ADDENDUM NO. 1

TO: Prospective Bidders and Others Concerned
 FROM: County of Henrico/Henrico County Public Schools
 DATE: June 4, 2012
 RE: Bid Request No: 12-9263-5JK
 Name of Project: Provide and Install Four (4) Walk – in Freezers

| FACILITY: LONGAN ELEMENTARY 9200 Mapleview Avenue | | SHEET #: 4 |

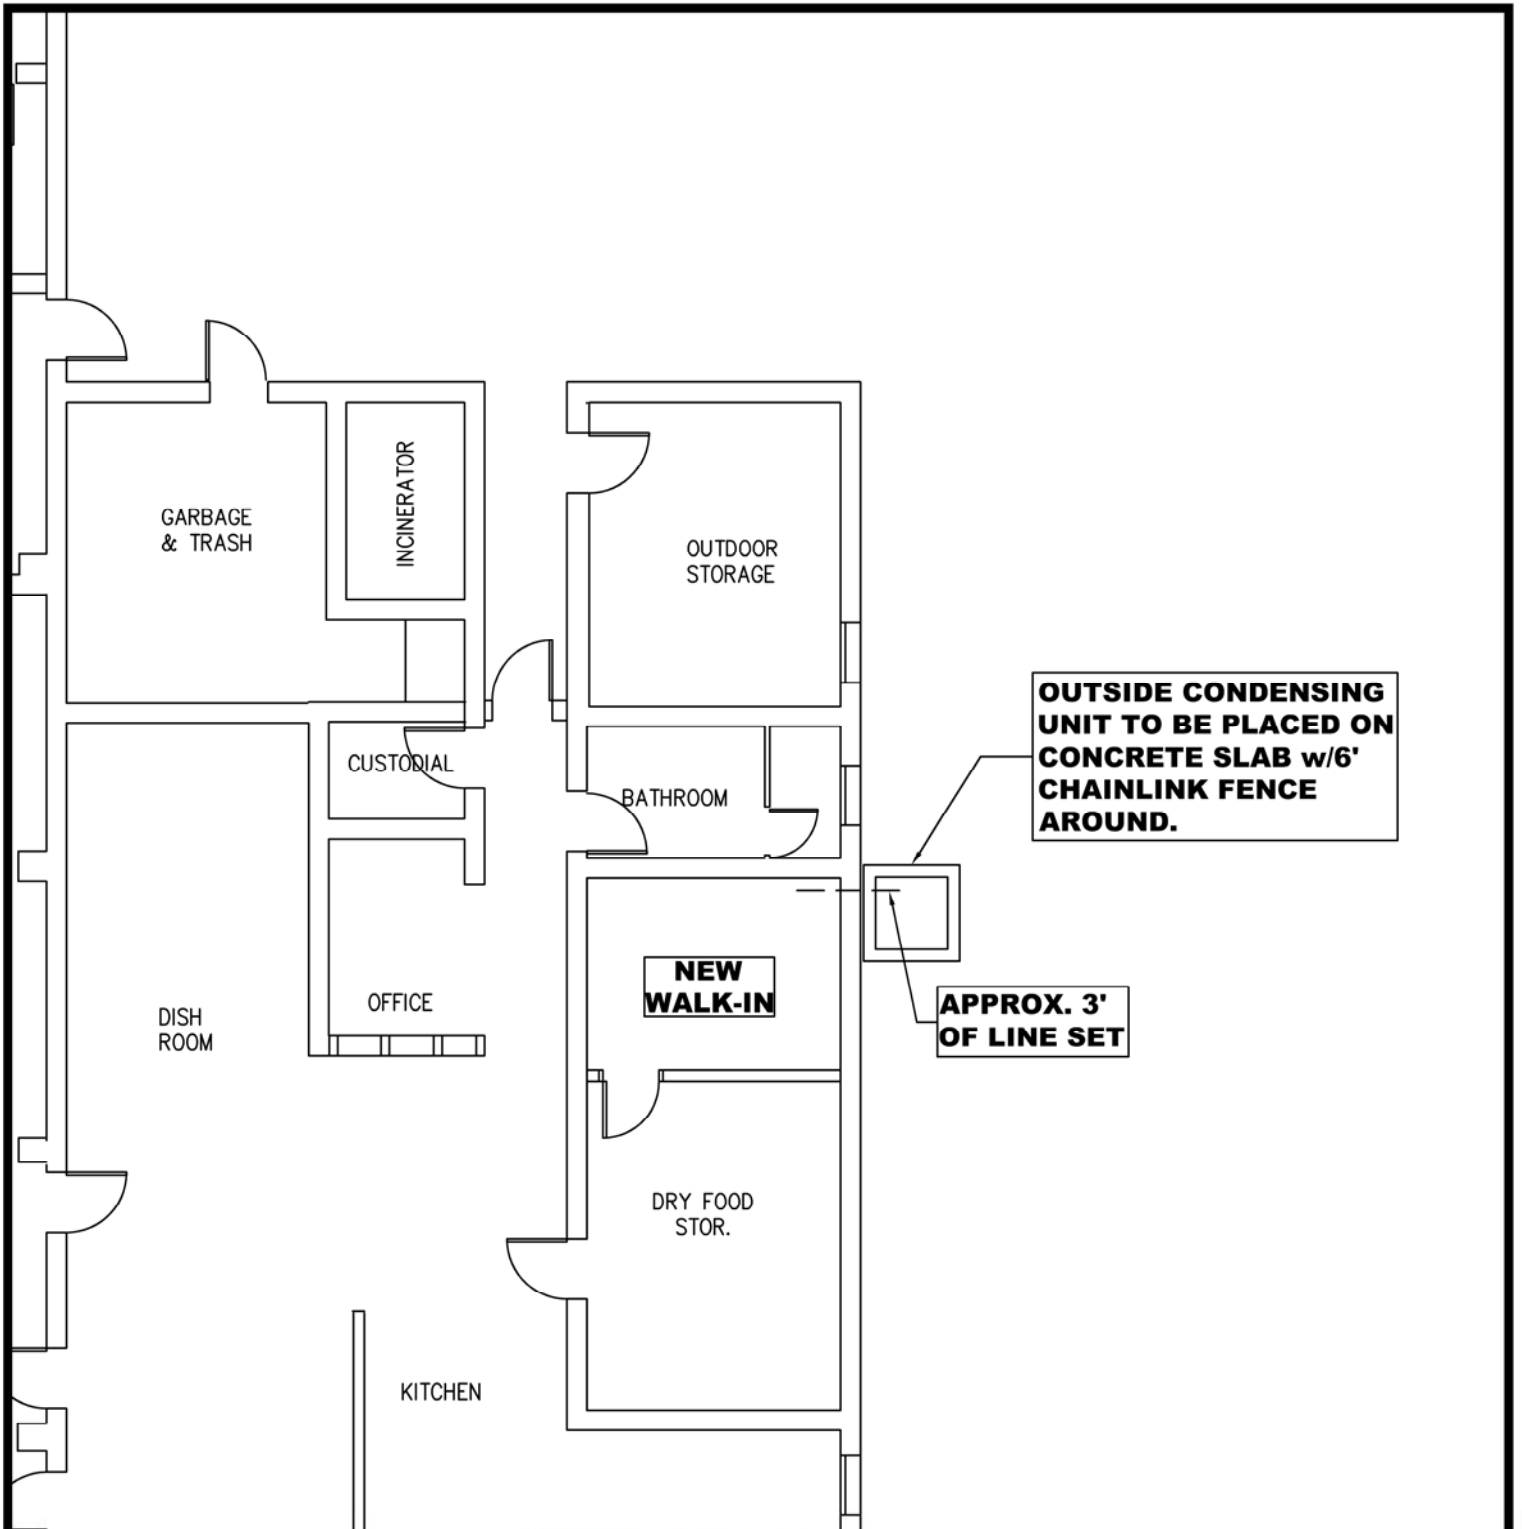
The condensing unit requires a concrete pad 6ft x 6 ft x 4" enclosed by a 6 ft tall chain link fence (including a top) with double access doors. (See attached drawing)

Condensate drain to grassy area with splash block Drain lines shall be routed to grade on the exterior of the building, provided with heat trace tape where subject to freezing temperatures, drains shall be trapped and protected from insects with #16 mesh stainless steel screen wire silver soldered over a threaded ¾" x 1" adaptor attached to the discharge opening

The shelving indicated on the drawings in the walk-in and storeroom shall be Eagle EagleGard epoxy or equal. The lowest shelf shall be placed 8" AFF to the surface of the shelf. The shelving in the storeroom shall be furnished in the quantity and sizes indicated with lowest shelf placed 8" AFF to the surface of the shelf. The Security Carts and Can Racks specified shall be furnished in addition the shelving indicated on the drawing.

The closure trim on the walk-in; the trim shall be of the same material and finish as the exterior of the walk-in and applied to the vertical and horizontal top of the walk-in enclosing the walk-in to the adjacent building walks preventing anything from falling behind and between building walls and the walk-in.

| FACILITY: HOLLADAY ELEMENTARY 7300 Galaxie Road | | SHEET #: |

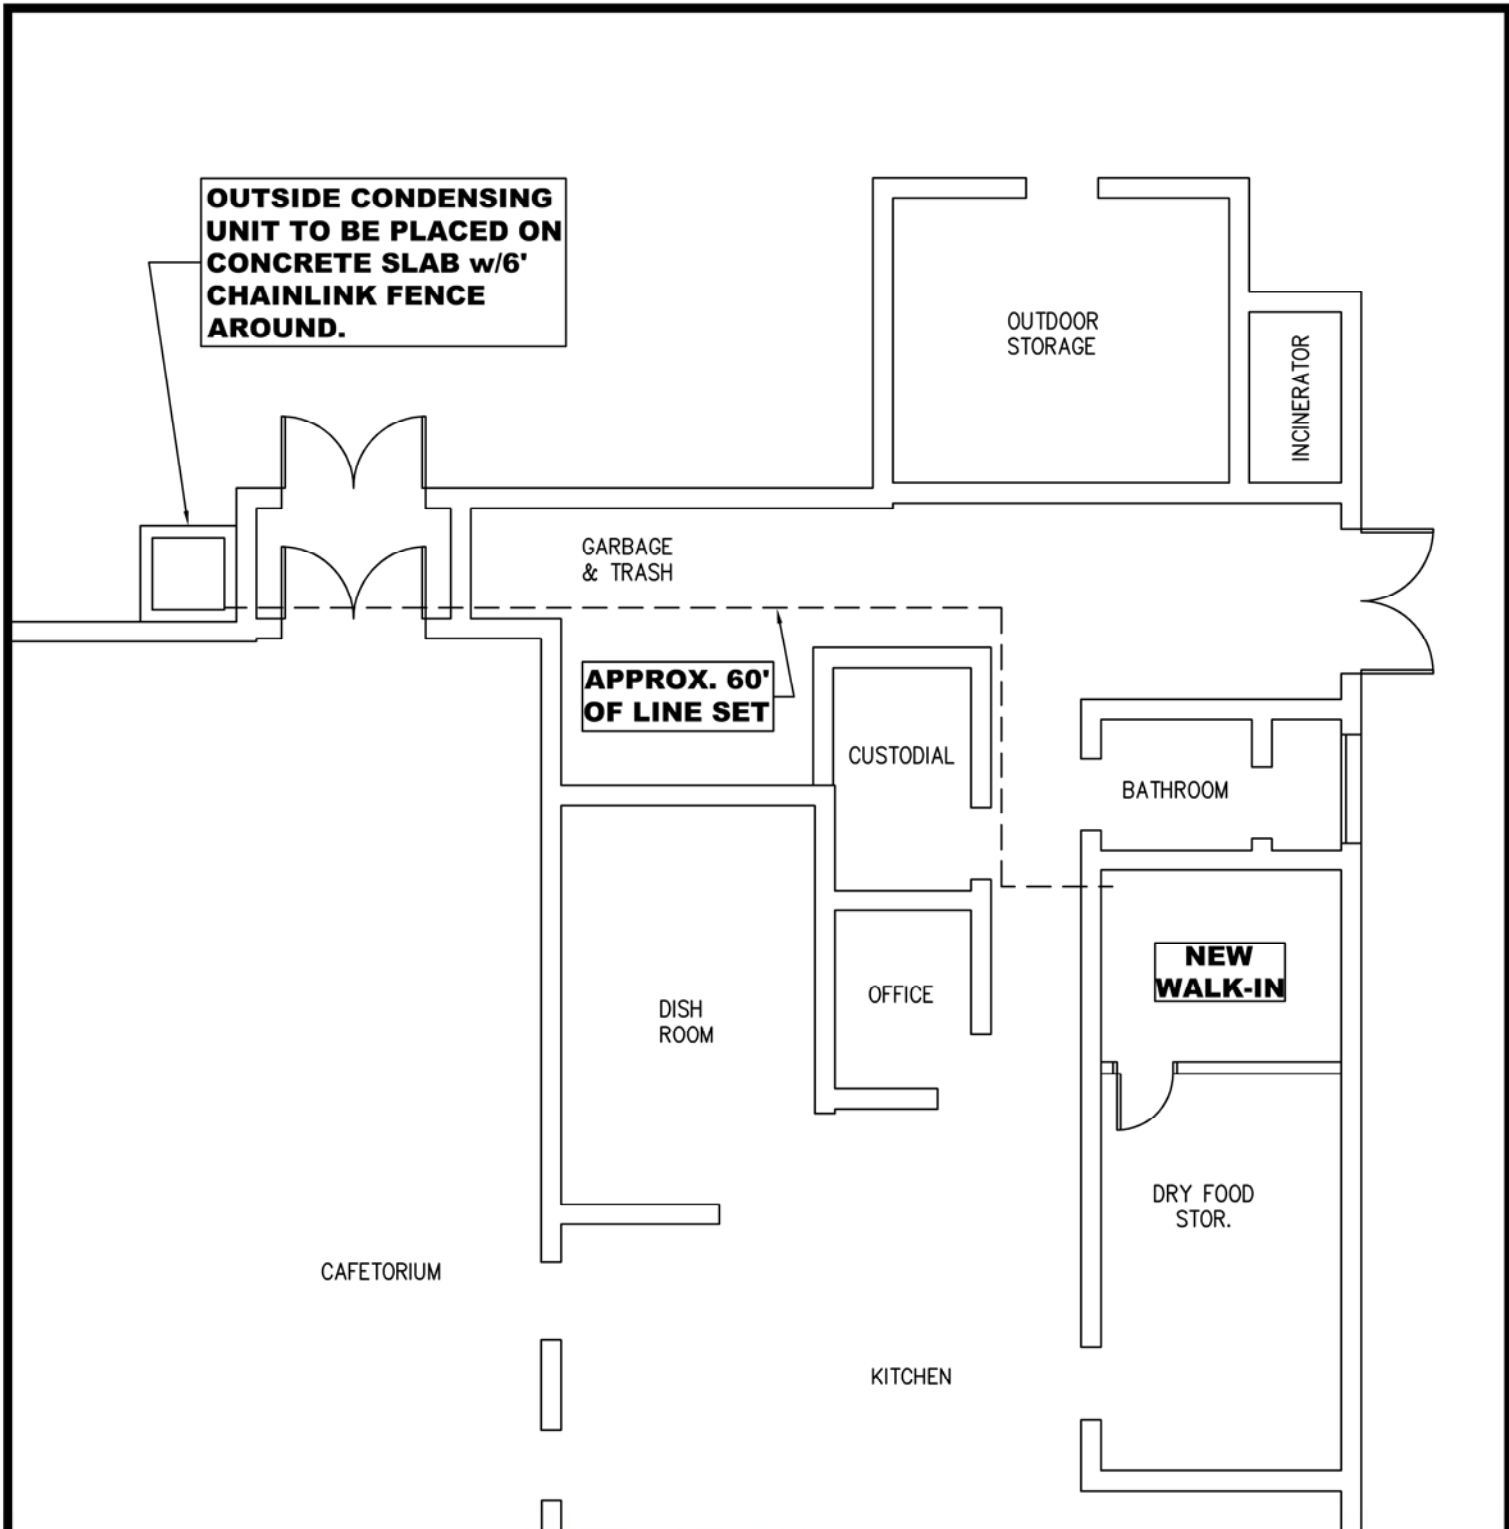
Condensate drain must be refrigerant grade hard copper, condensate drain shall be piped along wall to floor drain near corner of the storeroom.

The condensing unit requires a concrete pad 6ft x 6 ft x 4” enclosed by a 6 ft tall chain link fence (including a top) with double access doors. (See attached drawing)

The shelving indicated on the drawings in the walk-in and storeroom shall be Eagle EagleGard epoxy or equal. The lowest shelf shall be placed 8” AFF to the surface of the shelf. The shelving in the storeroom shall be furnished in the quantity and sizes indicated with lowest shelf placed 8” AFF to the surface of the shelf. The Security Carts and Can Racks specified shall be furnished in addition the shelving indicated on the drawing.

The closure trim on the walk-in; the trim shall be of the same material and finish as the exterior of the walk-in and applied to the vertical and horizontal top of the walk-in enclosing the walk-in to the adjacent building walks preventing anything from falling behind and between building walls and the walk-in.

| FACILITY: DUMBARTON ELEMENTARY 9000 Hungary Spring Road | | SHEET #: 2 |

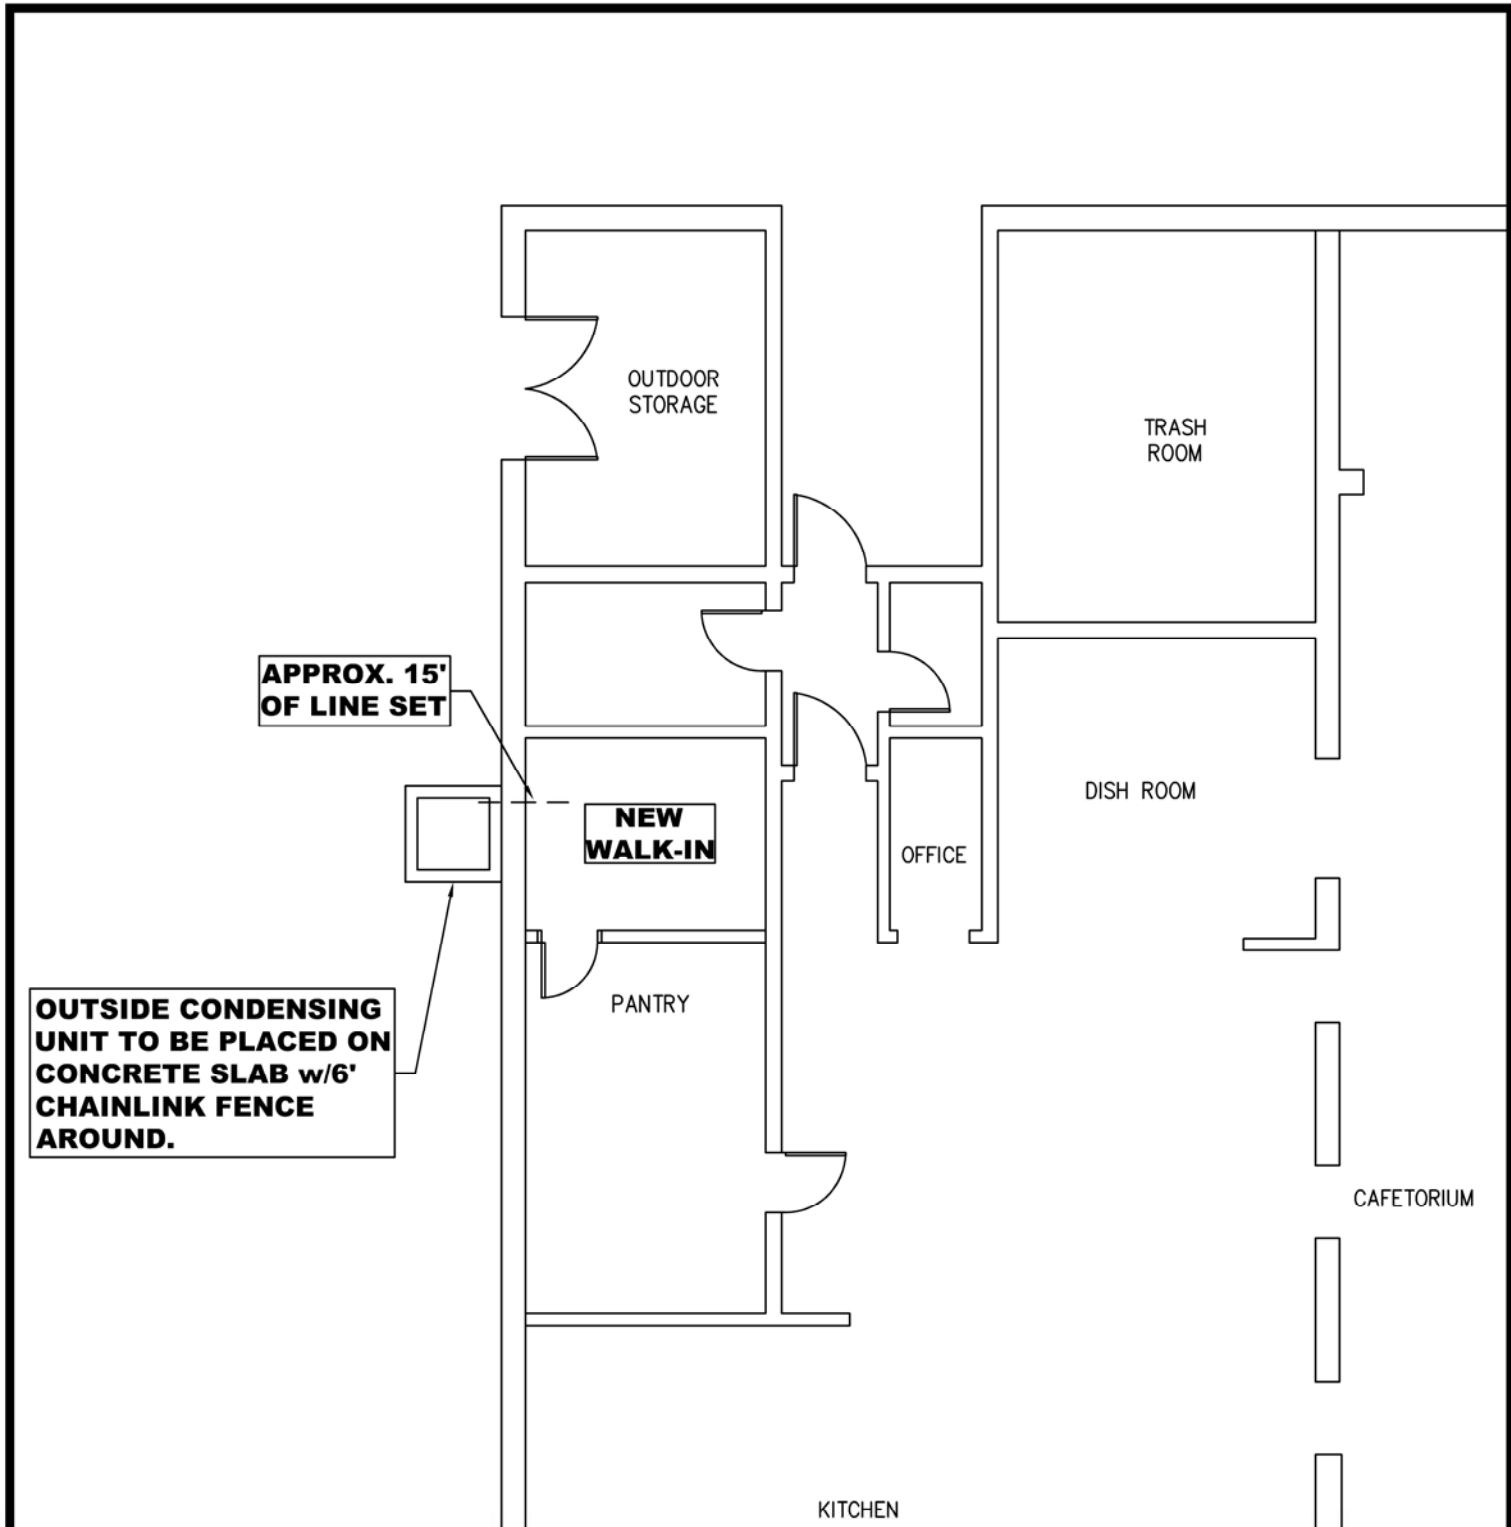
Sprinklers are present at school and building code will require an installation of a dry sprinkler inside of the freezer.

Floor drain (1) must be capped where new equipment will sit.

Condensate drain to run to outside of building into ditch Drain lines shall be routed to grade on the exterior of the building, provided with heat trace tape where subject to freezing temperatures, drains shall be trapped and protected from insects with #16 mesh stainless steel screen wire silver soldered over a threaded ¾" x 1" adaptor attached to the discharge opening.

The condensing unit requires a concrete pad 6ft x 6 ft x 4" enclosed by a 6 ft tall chain link fence (including a top) with double access doors. (See attached drawing)

The shelving indicated on the drawings in the walk-in and storeroom shall be Eagle EagleGard epoxy or equal. The lowest shelf shall be placed 8" AFF to the surface of the shelf. The shelving in the storeroom shall be furnished in the quantity and sizes indicated with lowest shelf placed 8" AFF to the surface of the shelf. The Security Carts and Can Racks specified shall be furnished in addition the shelving indicated on the drawing.

The closure trim on the walk-in; the trim shall be of the same material and finish as the exterior of the walk-in and applied to the vertical and horizontal top of the walk-in enclosing the walk-in to the adjacent building walks preventing anything from falling behind and between building walls and the walk-in.

| FACILITY: CARVER ELEMENTARY 1801 Lauderdale Drive | | SHEET #: 1 |

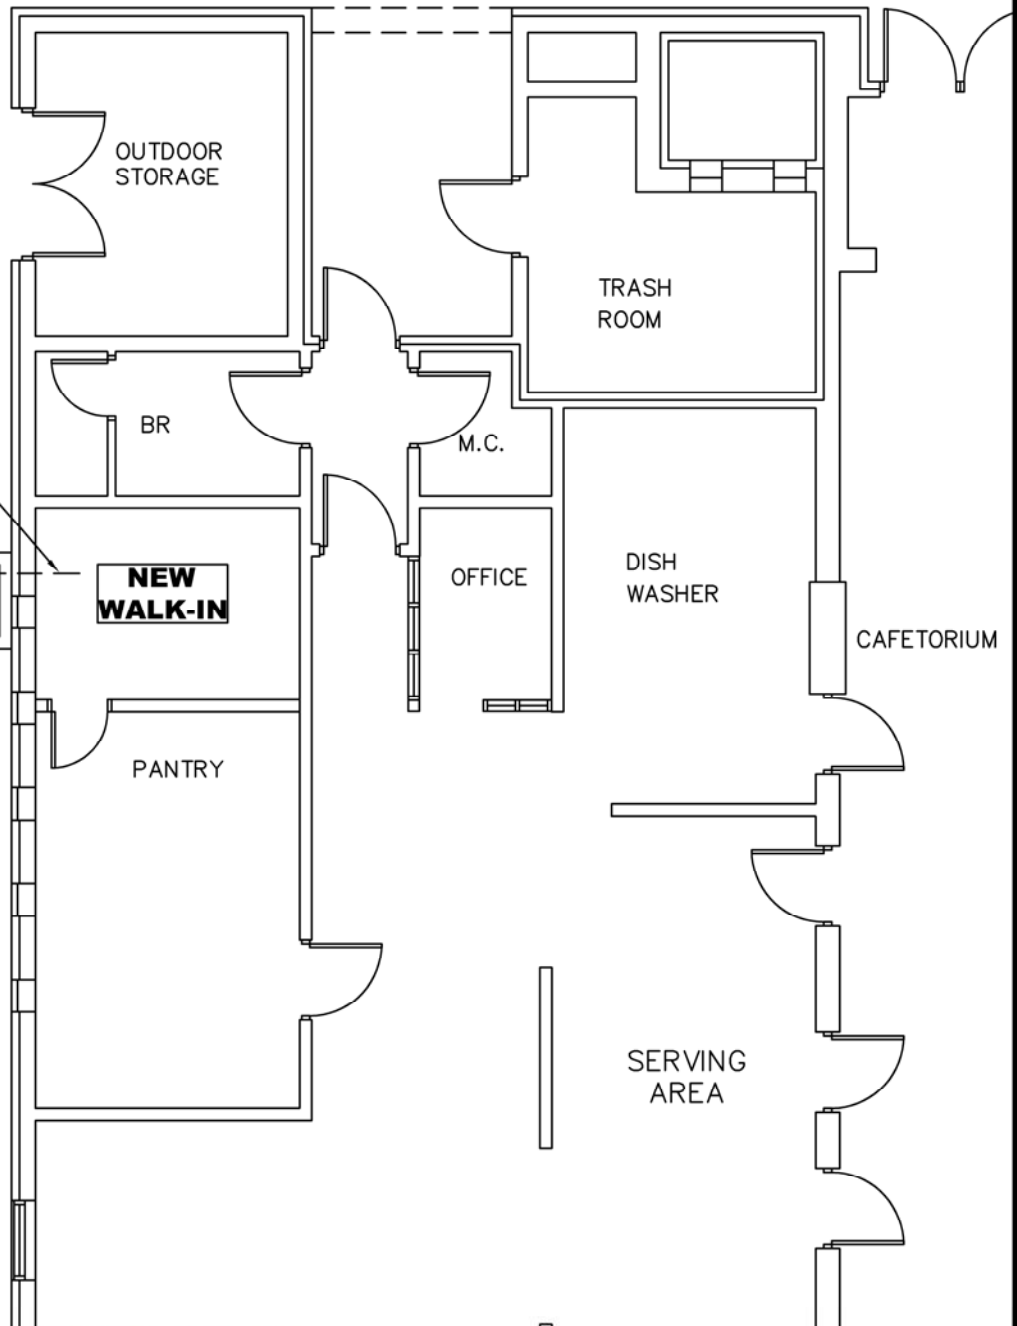
The condensing unit requires a concrete pad 6ft x 6 ft x 4” enclosed by a 6 ft tall chain link fence (including a top) with double access doors. (See attached drawing)

Has inside drain Condensate drain shall run in refrigerant grade hard copper, condensate drain shall be piped along wall to floor drain near corner of the storeroom.

No shelving, security carts and can racks shall be required at this school; shelving within the walk-in shall be Eagle EagleGard epoxy or equal as indicated on drawing.

The closure trim on the walk-in; the trim shall be of the same material and finish as the exterior of the walk-in and applied to the vertical and horizontal top of the walk-in enclosing the walk-in to the adjacent building walks preventing anything from falling behind and between building walls and the walk-in.
